Title:                   Advisory Committee on Reactor Safeguards  
                                  US EPR Subcommittee: Open Session

Date:                    Monday, November 14, 2011

The purpose of the meeting is to continue our review of the SER with Open Items for the design certification document submitted by AREVA NP for the US EPR design and the SER with Open Items for the combined operations licence application submitted by UniStar for the Calvert Cliffs nuclear power plant Unit 3.

# Debris Retention System

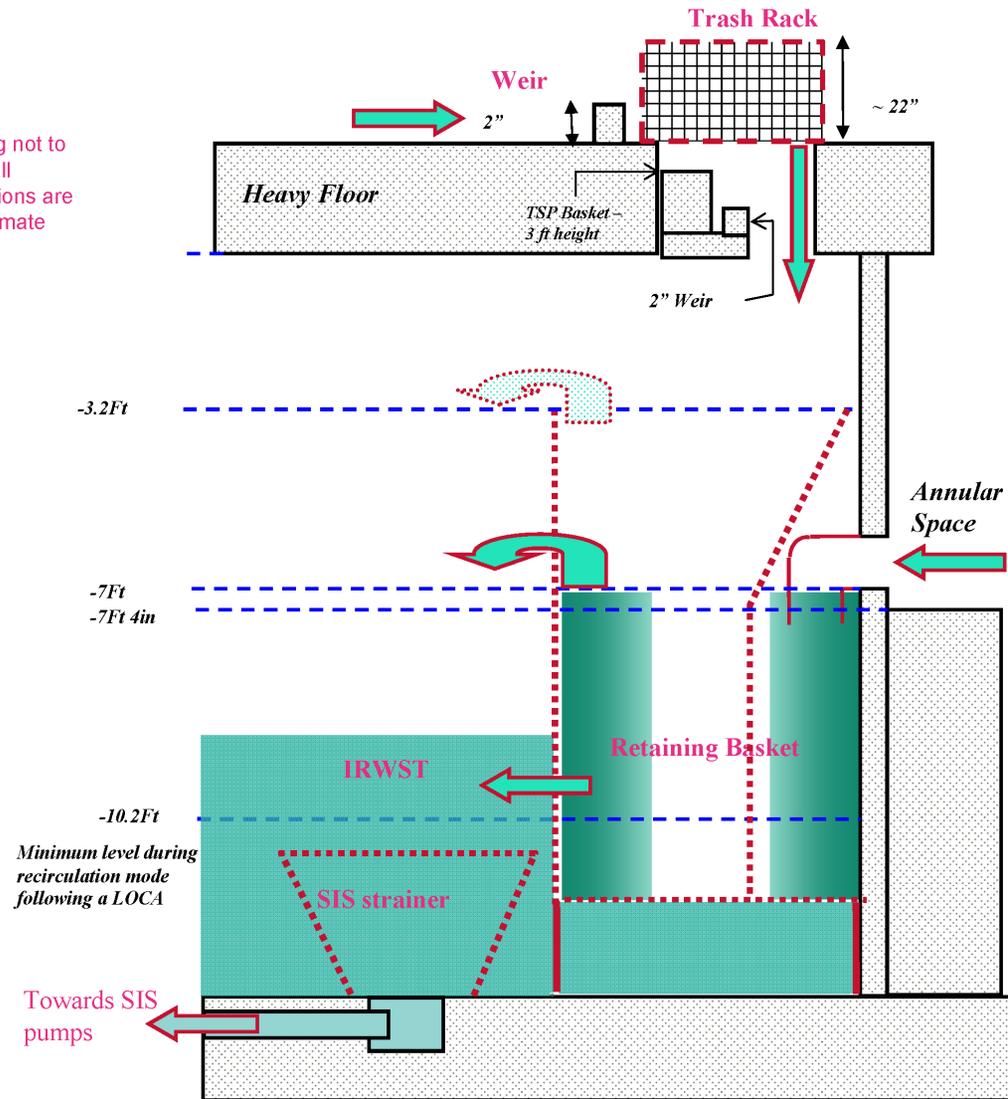
13           MEMBER STETKAR:   Kevin, just one and it's  
14 sort of a geometry question. Off to the right there,  
15 there's an arrow coming in from the annulus. So in  
16 principle, if the retaining baskets fill really full,  
17 they could spill over out into the annulus?

## **9.2.8 SCWS-Challenges**

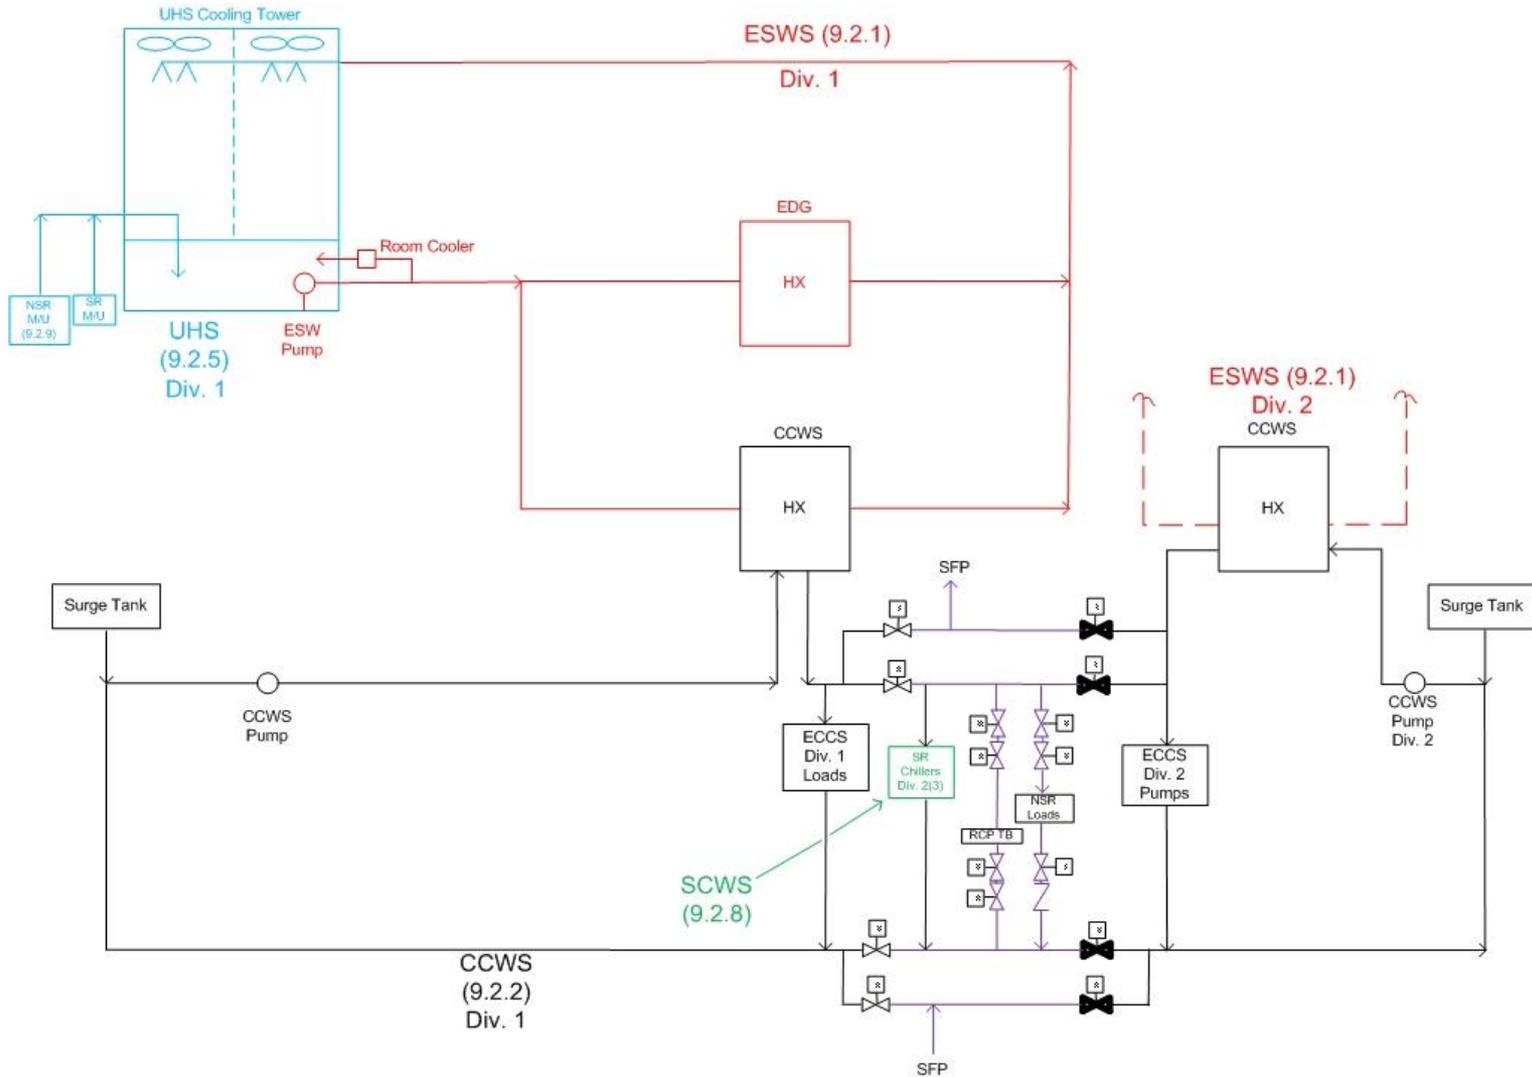
- **SCWS Water Hammer Considerations**
  - FSAR R/2 modified to add clarification:
    - Pressurized expansion tanks with nitrogen
    - Specified closing valves speed- slow enough to prevent damaging pressure increases
    - Chapter 14 testing – tests to verify there is no evidence of a water hammer
